EU Peer Review Report of the Türkiye Stress Tests

13 November 2024

Türkiye started negotiations with the Russian Federation to build a nuclear power plant (NPP) at the Akkuyu site in Türkiye in February 2010. The negotiations concluded with an Intergovernmental Agreement based on a 'build-own-operate' model. The Agreement was signed on 12 May 2010. Based on the Agreement, the Akkuyu Nuclear Power Plant Electricity Generation Joint Stock Company (Akkuyu Project Company, APC), responsible for the construction and operation of 4 Water Water Energetic Reactor (Vodo- Vodyanoi Energetichesky Reaktor, VVER), was established. Each unit is expected to produce 1200 MW of power. The predecessor of the Nuclear Regulatory Authority of the Republic of Türkiye (NDK), Turkish Atomic Energy Authority (TAEK), recognised APC as the owner (referred to below as 'the Applicant') on February 7, 2011.

Left: comparison of hazard curves PSHA 2017 and PSHA 2021

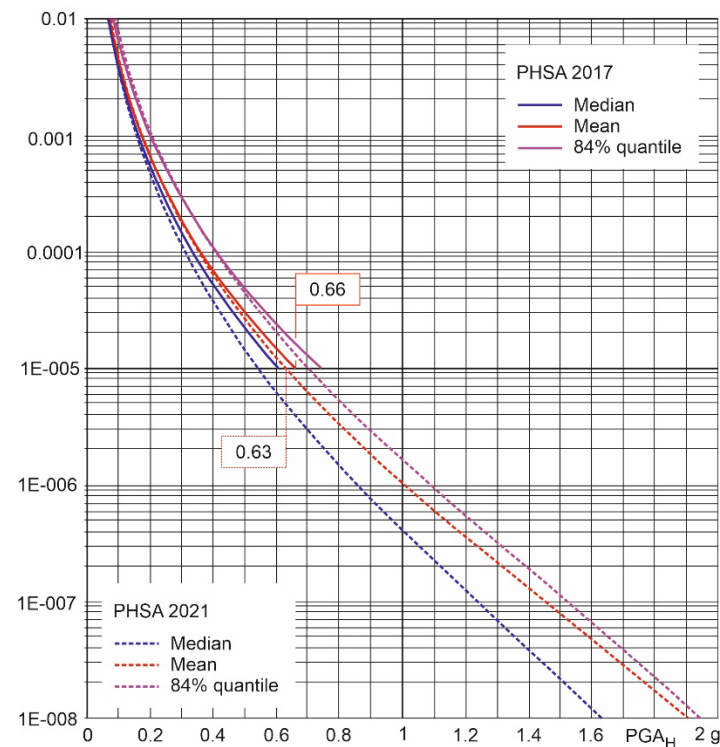
During the 2022 country visit, NDK stated that these hazard curves differ from the curves in PSHA 2017 (Site Parameters Report):

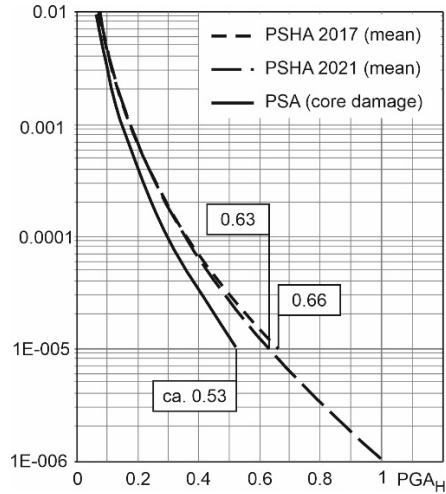
<p>The PRT considers that the seismic margins (HCLPF) are small for a significant number of SSCs important for safety, such as the inner containment (0.55 g), the emergency batteries (0.41 g), the emergency power supply tunnels (0.38 g), the SPF (0.57 g), anchoring and ventilation systems.</p> <p>The NR and the document Topic_1-44.pdf provided by NDK identify numerous SSCs with HCLPF values which are below the value $1.4 \times \text{PGA}_{\text{SSE-h}} = 0.543 \text{ g}$ and several SSCs which do not meet DB requirements of $\text{PGA}_{\text{SSE-h}} = \mathbf{0.388 \text{ g}}$ (11UQZ and 12UQZ tunnels for emergency power supply system cables and essential service water systems).</p> <p>The loss of the confinement function of the containment at 0.68 g (HCLPF) corresponds to an occurrence probability of about 10^{-5} per year, according to the PSHA results. It must be clarified whether this corresponds to a cliff edge.</p> <p>The low seismic margins of a significant number of SSCs important for safety lead to a contribution of the seismic risk (S-PSA) to the overall plant risk (in terms of FDF) which is very large: 80% by the reactor core, 91% including reactor core, spent and fresh fuel storage.</p> <p>These numbers indicate an unbalanced design which does not duly account for seismic hazards. The PRT expects that the seismic contribution to the overall plant risk in terms of LRF and/or LERF is also very high. Addressing seismic issues at this early phase is therefore highly important, to meet the chance of design modifications during the construction phase and to reduce the risk contribution of seismic events to an acceptable level.</p> <p>With respect to SSCs, which need sufficient seismic margins above the SSE to cope with DEC, it seems clear neither whether all necessary SSCs have been identified nor if all identified SSCs are sufficiently designed to ensure their integrity and function in accordance with their role in support of the Defence in Depth (DiD) levels.</p> <p>The seismic margins of SSCs required to prevent fuel damage and large or early releases (i.e. those relied on in DiD Levels 3 and 4) are only acceptable if they ensure CDF and LERF values which are low enough to meet the acceptance criteria (see T1-00 and T1-01).</p> <p>To ensure a suitable review and assessment is carried out, a consistent concept should be available that describes and justifies the seismic margins that SCCs need in order to comply with acceptable CDF and LERF values. At present such a demonstration or documentation has yet to be presented to the PRT.</p> <p>Recommendations:</p> <p>T1-10-1. High priority: PRT expresses concern about the calculated seismic fragilities (HCLPF values calculated by the designer; see T1-09) and suggests that NDK arrange for an in-depth review of methods and calculation of HCLPF values.</p> <p>T1-10-2. High priority: The PRT questions the data reported on the seismic resistance of the reactor core and the reactor shutdown system (full control rod insertion within the required time window). The PRT recommends reviewing the fragility calculation for the reactor core</p>

<p>(needed for both SMA and seismic PSA) and the licensee's approach to ensuring safe shutdown of the reactor by inserting control rods during seismic events.</p> <p>T1-10-3. High priority. The PRT recommends that NDK:</p> <ol style="list-style-type: none"> 1. not accept the margins of SSCs important for safety with HCLPF < 0.543g; 2. take necessary action to ensure compliance.
T1-11	<p>Range of earthquake leading to severe fuel damage</p> <p>Description:</p> <p>The NR report gives values of the mean annual fuel damage frequency (FDF) derived from a seismic PSA. Calculations discretised the mean seismic hazard curve for the site ground motion parameter PGA, based on which the component fragilities of SSCs are developed, into 8 intervals between 0.2 g (occurrence probability = 4×10^{-4}/year) and 0.6 g (occurrence probability = 5×10^{-6}/year) with steps of 0.05 g.</p> <p>The total mean annual FDF of core and pool fuel is stated with 5.59×10^{-6}; the individual FDF values calculated for the core fuel and the pool fuel are 4.64×10^{-6} and 1.84×10^{-6}, respectively. The values are below 10^{-5} per NPP unit per year, specified in the Russian nuclear standard NP-001-97.</p>  <p>Left: comparison of hazard curves PSHA 2017 and PSHA 2021 (broken lines) with the hazard curve used for seismic PSA and calculation of FDF, according to Figure 7 of the NR (bold continuous line).</p> <p>PSHA 2017 (Site Parameters Report): Hazard curves considering all source models and using the reported σ GMPE (AKU-BDD0132 Rev. B04 20.01.2017, p. 6.6-61.</p> <p>PSHA 2021 (WorleyParson): Hazard curves for PGA (truncation at 3σ) used for PSA 2021.</p>

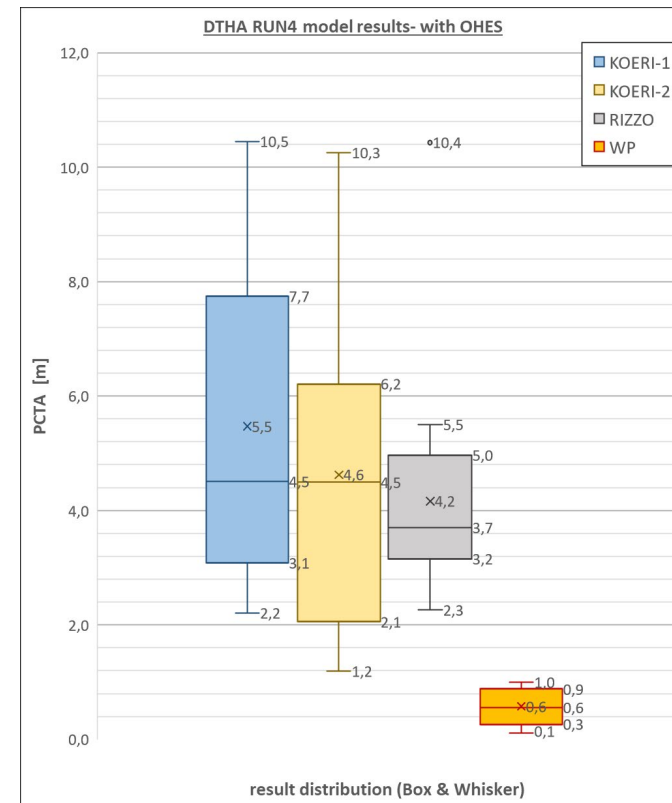
The Box & Whisker (right) representation of the 4 data sets shows that the WP data set is completely outside of the range of all the other data sets. The WP interquartile range (i.e. Q3-Q1 or P75%-P25%, containing the 50% most central values of each data set) of WP does not overlap any of the interquartile ranges of the other data sets. The highest value of the WP data set (+1.0 m) is below the lowest value of the 3 other data sets (+1.2 m).

As the tsunami DB is currently based on a statistical combination of the runup modelling results from the four models, the inclusion of the unrealistic WorleyParsons results (i.e. a statistical outlier) leads to an inappropriate reduction of the calculated tsunami DB.

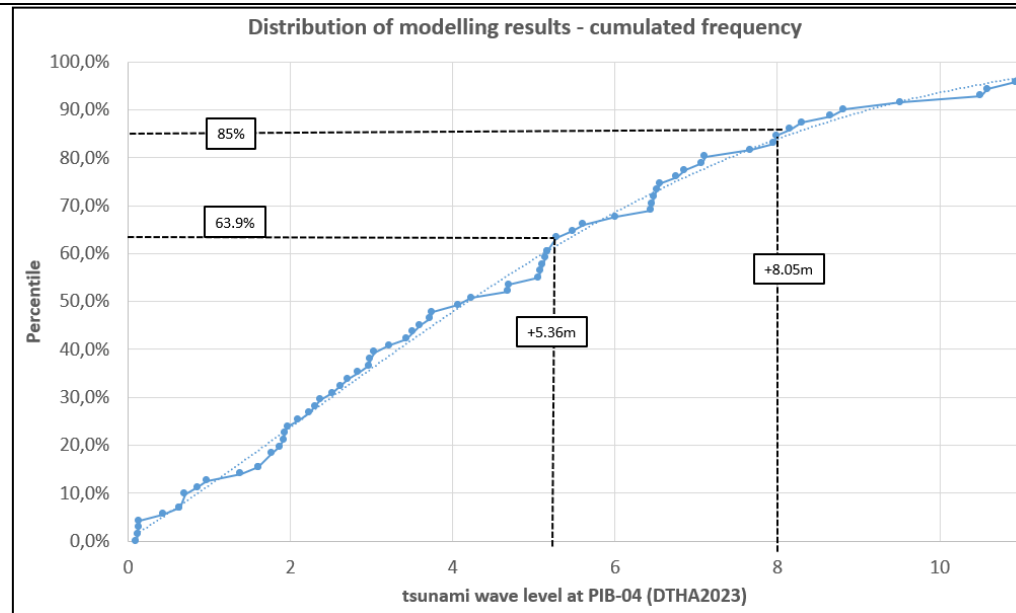
<p>A true PTHA should include all relevant seismogenic sources, not only RUN-4. It should provide reliable hazard curves for different confidence levels (mean, median and 84% quantile), based on a sound logic tree approach with due account of uncertainties, and extending with enough confidence well beyond an exceedance frequency of 10^{-4}/yr.</p> <p>A similarly unusual statistical combination is used in the DTHA 2023 report (+4.63 m+0.73 m+2.08=+7.44 m). A standard DTHA would have concluded that the DB tsunami should be based on the maximum water level from the range of all tsunami heights from numerical calculations for all the possible seismogenic sources. According to the existing modelling performed (cf. rupture scenarios KOERI-2-07c, KOERI-1-09, KOERI-1-07, RIZZO-10, etc.), this would lead to a DB tsunami around 6-7 meters higher than the current +7.44 m value.</p> <p>[B] The current definition of the DB tsunami is not 'unlikely to be exceeded with a high degree of confidence'.</p> <p>The graph below presents the distribution of the 4x18 PCTA data values modelled for the RUN-4 scenario, estimating the tsunami wave height at the PIB-04 point in the Akkuyu bay (in the NE corner of the inlet channel). Modelling results have been sorted from the smallest to the highest, and the percentile of each value has been calculated.</p> <p>Using a +5.36m value (value used in the Akkuyu DB tsunami, based on NP-064-05) would give only a 63.9% confidence that the tsunami runup will not be exceeded. This +5.36m value is exceeded by more than one third of all tsunami scenarios modelled. To have a 85% confidence of non-exceedance, a value of +8.05m should be used. To have a 95% confidence of non-exceedance (which is the intended target considered in NP-064-05), a value of +10.75m should be used.</p>

The Non-Exceedance Probability (NEP) of 63.9% is lower than typical NEP levels used for external hazards (for instance the 85% and 95% levels commonly agreed in probabilistic assessments, or even the 100% level used in deterministic approaches in some countries, such as e.g. US NRC NUREG/CR-7223¹²⁴) that recommend using the maximum credible calculated tsunami height as the DB tsunami.

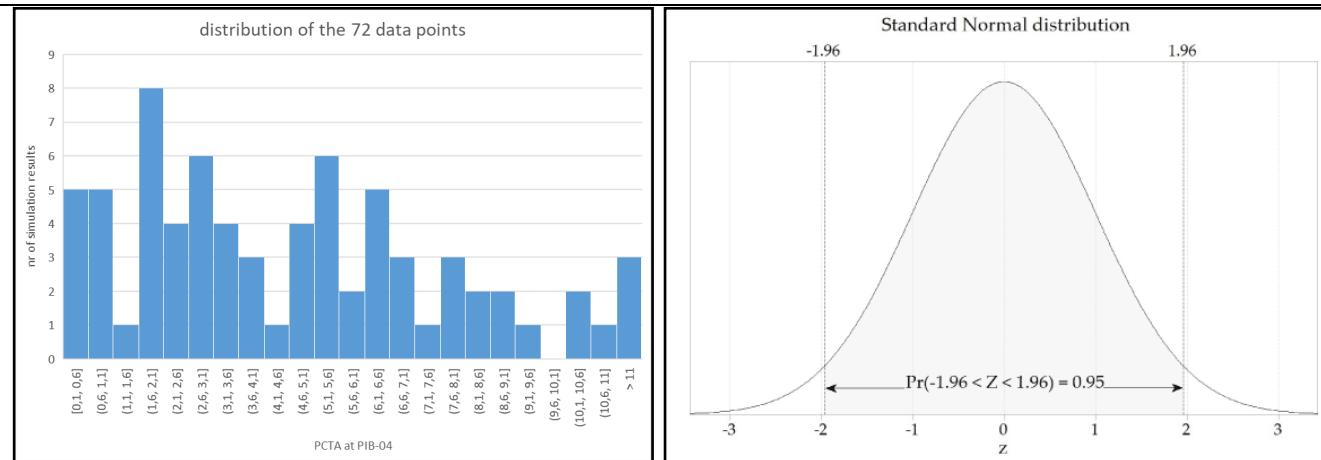
The formula used to calculate the DB tsunami in NP-064-05 is 'mean + 1.96 × Std.Dev./√n', which assumes a normally distributed PCTA based on the Central Limit Theorem. Given that tsunami runup values represent real-world physical phenomena, it is crucial to validate the assumption that it follows a normal distribution, especially if extreme values (tails of the distribution, i.e. 95% NEP) are of concern for safety measures. However, the diagram below shows clearly that the distribution of the 72 values is not a normal distribution. Therefore, simplified formula based on the Normal distribution cannot be used without leading to very rough approximation.

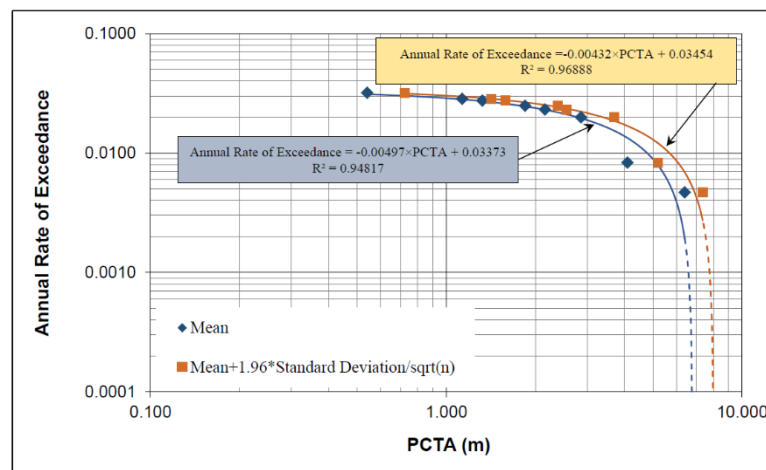
past and future landslides, it should be assumed that any local landslides that have occurred in similar geophysical conditions as found near the NPP may in the future occur immediately offshore of the NPP. For example, if there is geological evidence of a submarine landslide along the shelf break at a location distant to the NPP but in a similar geophysical configuration, then that landslide should be considered to possibly occur at the shelf break immediately offshore of the NPP. This approach can be discarded only with a clear and convincing geological argument against permitting a change in the future landslide to a location closer to the NPP. Due to an overall lack in understanding of the evolution of large submarine landslides and the waves that they generate, a highly conservative approach must be employed to initially estimate the waves generated.'

During the plant walkdown and subsequent discussions it was clarified that there is very low risk that a significant landslide-induced tsunami could occur following the (for instance earthquake-induced) collapse of parts of Babadil islets directly facing the Akkuyu site. This is due to the absence of evidence of past landslides on the seabed around the islets, as well as to the configuration and limited volume of the islets. This topic is considered closed.

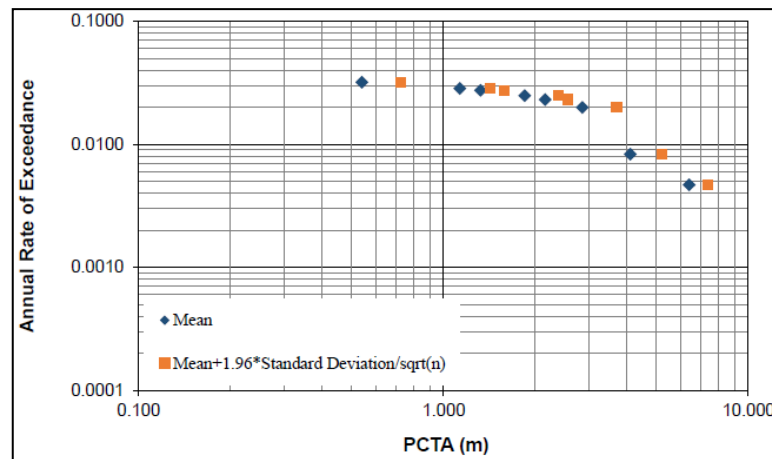
The tsunami hazard curve saturates below exceedance probabilities of 10^{-3} /year at around +8 m.

[A] The PRT doubts the reliability of the tsunami hazard curve for exceedance probabilities below about $4.7 \times 10^{-3}/\text{yr}$, i.e. the occurrence probability at which the hazard curves provided in the 2017 PTHA saturate. In general, tsunami hazard curves very rarely present complete saturation. When saturation is present, usually tsunami hazard curves saturate at much lower exceedance probabilities (typically below $10^{-5}/\text{yr}$).

The raw distribution of 8 points from the 2017 PTHA report does not show any obvious saturation (cf on the left). The choice of an extrapolation curve that saturates seems arbitrary. As the seismic hazard does not saturate at least up to $10^{-5}/\text{yr}$, there is no reason why the earthquake-induced tsunami hazard would saturate before this exceedance probability.

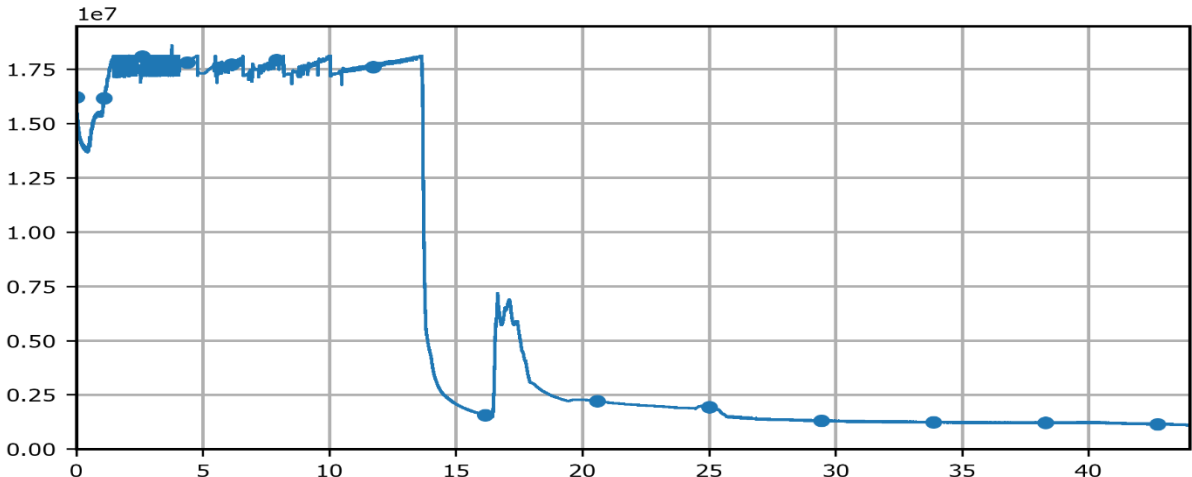
T3-18	<p>Functioning of PRZ PORV together with KTP during overpressurized scenarios</p> <p>Description:</p> <p>According to the stress test specification, quick depressurisation to 1 MPa must be ensured.</p> <p>In addition, on answers 22, 60 and 66 NDK commented that it is waiting for a detailed analysis for further review of the functioning of PRZ PORV, together with KTP during overpressurised scenarios in the primary circuit, and that the applicant should justify the quick depressurisation to 1 MPa to avoid failure of the core catcher.</p> <p>According to the safety analysis report, 'in the context of design-extending accidents involving KTP (EGRS) core meltdown, this system is used to reduce the primary pressure by up to 1 MPa by venting the medium from the PRZ to the containment, according to the accident management instructions.'</p> <p>PSA calculations are based on the assumption that PRZ PORV and EGRS are opened together by the operating personnel to reduce the pressure below 1 MPa. This information is provided in the reply to the additional information requested from the Akkuyu NPP and in the safety analysis report. The situation of important events related to severe accidents was calculated according to time and the relevant results were presented in tables and graphs by the Akkuyu NPP. According to the calculations made, PRZ PORV and EGRS are turned on at 13.7 hours after an initiating event occurs, and it is indicated in the relevant graph that the primary circuit pressure falls below 1 MPa.</p>

Finding nr	Peer review team finding
	 <p>Assessment: In the event that cooling of the reactor is lost, depressurisation is performed by the joint operation of PORV and the emergency gas removal system. As both systems are needed, no diversity is ensured for the depressurisation of the reactor in the event of loss of cooling capability. In addition, these systems are not dedicated for this function (and this DiD level). This lack of diversity seems to weaken the practical elimination of a high-pressure ejection of the core.</p> <p>Recommendation The issue of the primary circuit depressurisation by the means dedicated to Level 4 DiD must be carefully analysed and, if relevant, the appropriate measures must be developed and implemented.</p>
T3-19	<p>ADGS restricted set of mechanisms</p> <p>Description: During the desktop review the PRT received the information that an 0.4 kV air-cooled standby diesel generator supplies power to a restricted set of mechanisms, which are used for the management of beyond design-basis accidents:</p> <ul style="list-style-type: none"> - an alternate intermediate circuit pump installed in the first train of the essential load intermediate system KAA; - a primary train spray pump; - two emergency boron input pumps of the first train of the JND system;
